Addendum No. 2
October 27, 2015

Project: Our Redeemer Lutheran Church Addition
Sioux Falls, South Dakota
Project No. 2513

Architect: Architecture Incorporated

SD-7 SD-7 SCALE: 1" = 20'-0"

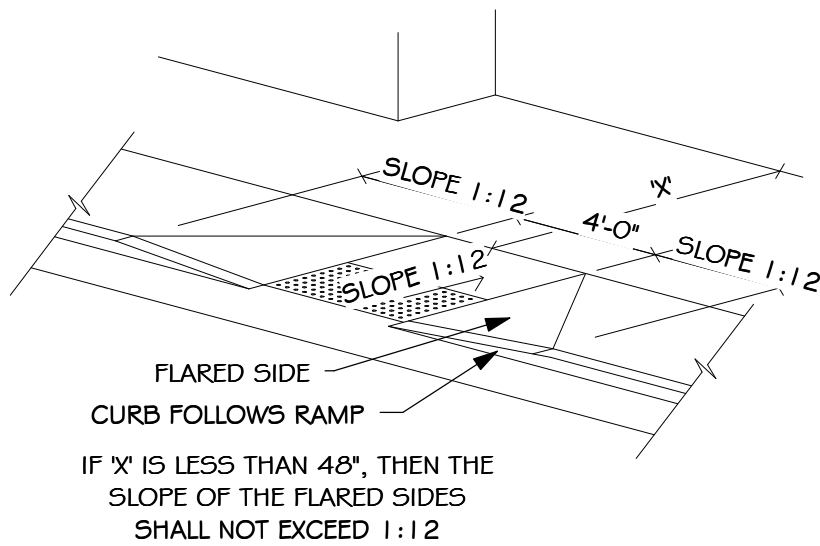
REMOVE EXISTING CONCRETE CURB,
GUTTER AND SIDEWALK.

INSTALL NEW CONCRETE CURB, GUTTER,
SIDEWALK AND ADA DIMPLE PADS.
SEE SD-8 FOR MORE INFORMATION.

SD-8 SCALE: 3/4" = 1'-0"

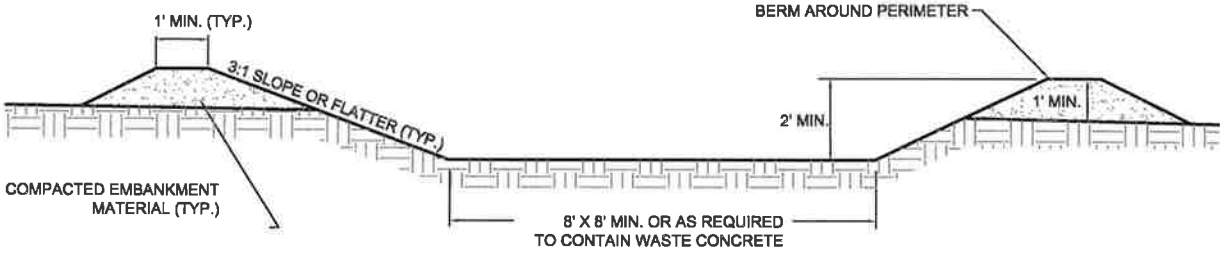
CURB RAMP W/PANEL

**PLATE
NUMBER
734.28**

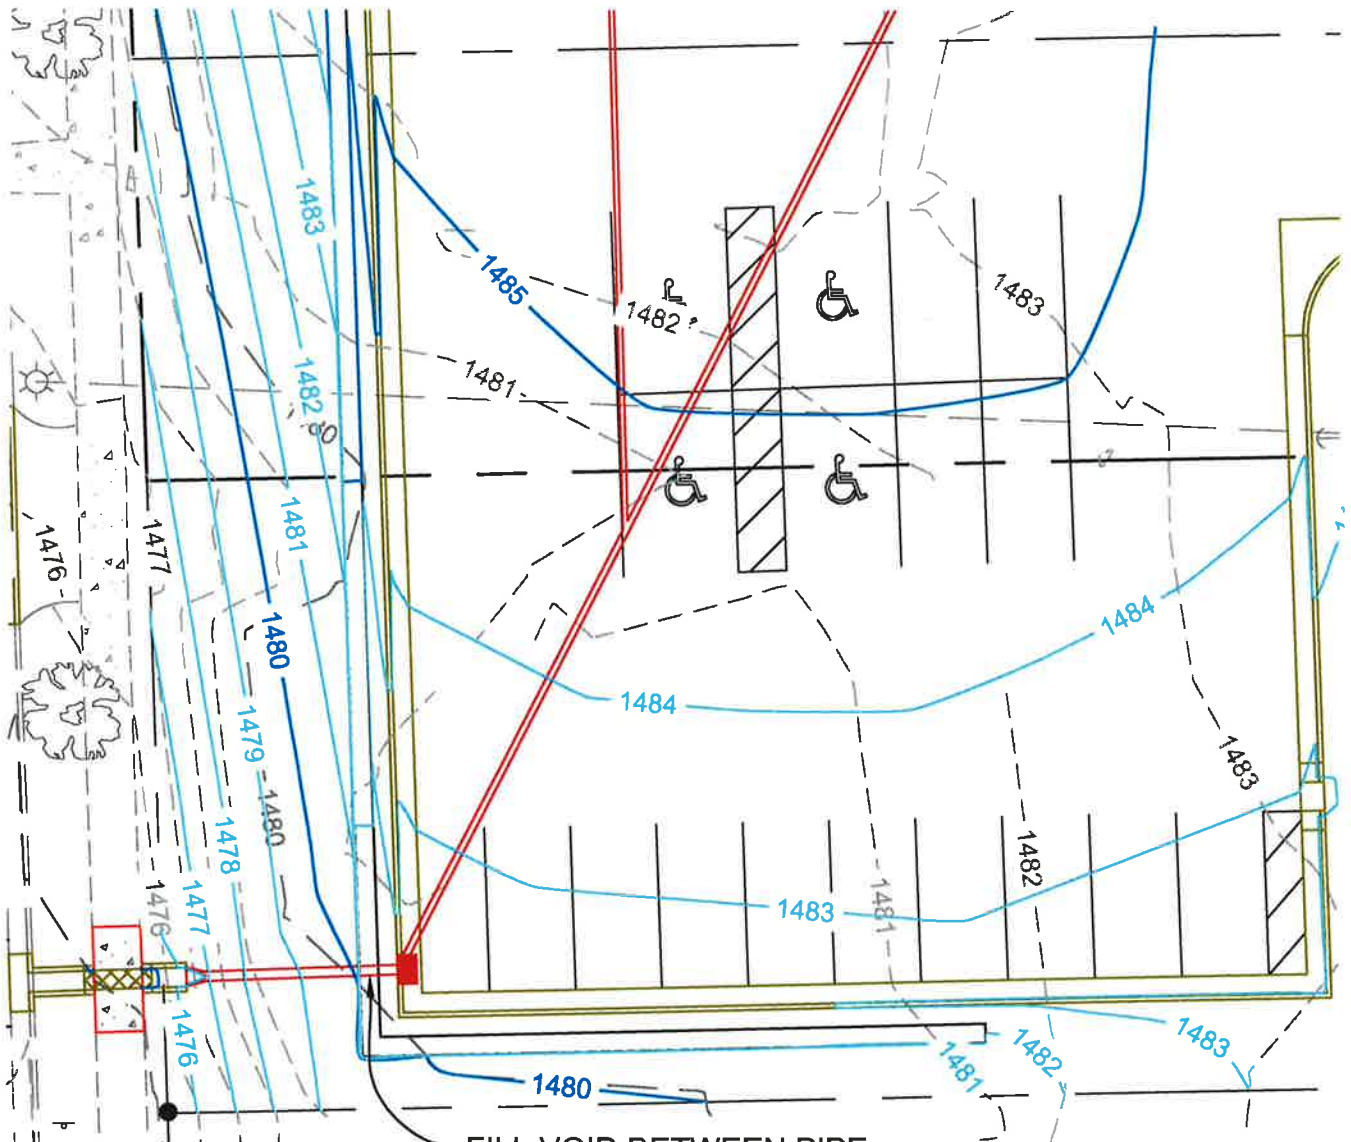
- 1) Sheet C2.21, the grading along the south side of the retaining wall shall be revised as per the attached exhibit.
- 2) Sheet C2.21, the Contractor shall fill the void between the 12” storm sewer and the retaining wall units with concrete where indicated on the attached exhibit.
- 3) Sheet C2.20, the Contractor shall provide a Concrete Washout Facility as per the attached detail within the proposed work limits but not located within a drainage path.

- 1. CONCRETE WASHOUT FACILITY SHALL BE INSTALLED PRIOR TO ANY CONCRETE PLACEMENT ON SITE.
- 2. A SIGN SHALL BE INSTALLED ADJACENT TO EACH WASHOUT FACILITY TO INFORM CONCRETE EQUIPMENT OPERATORS TO UTILIZE THE CWF.
- 3. THE CONCRETE WASHOUT FACILITY SHALL BE REPAIRED AND ENLARGED OR CLEANED OUT AS NECESSARY TO MAINTAIN CAPACITY FOR WASTED CONCRETE.
- 4. WHEN CWF ARE NO LONGER REQUIRED FOR THE WORK, THE HARDENED CONCRETE AND MATERIALS USED TO CONSTRUCT THE CWF SHALL BE REMOVED AND DISPOSED OF.
- 5. WHEN THE CONCRETE WASHOUT FACILITY IS REMOVED, THE HOLES, DEPRESSIONS OR OTHER GROUND DISTURBANCE SHALL BE BACKFILLED, REPAIRED AND STABILIZED.
